# TECHNICAL BULLETIN

LT310-001

## **SECTION: 310-01 (Fuel Delivery System - 19)**

Discovery II Td5 Poor Starting/Noisy Fuel Pump

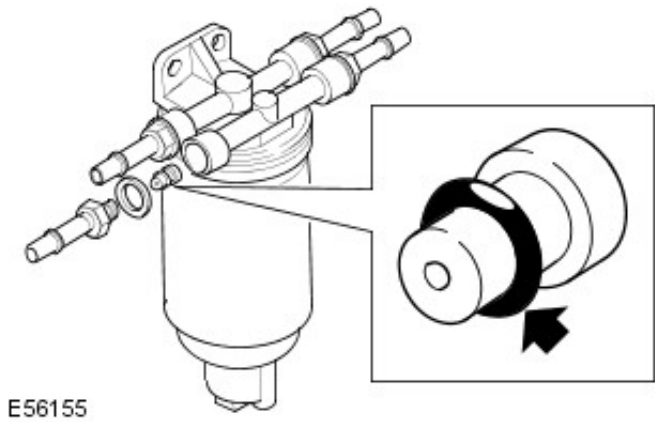
**Cause:** The O-ring seal on the fuel filter air bleed valve may be split, allowing air into the fuel system (If air is being introduced into the fuel system, it will make the primary fuel pump sound noisy).

1 Confirm that the O-ring described is at fault:

**4** Using a 19mm spanner, unscrew the brass adaptor from the assembly.

**5** Withdraw the air bleed valve from inside the brass fitting. Inspect the O-ring and plastic body for splits and damage.

**6** If the O-ring is damaged, renew parts provided in the service repair kit.
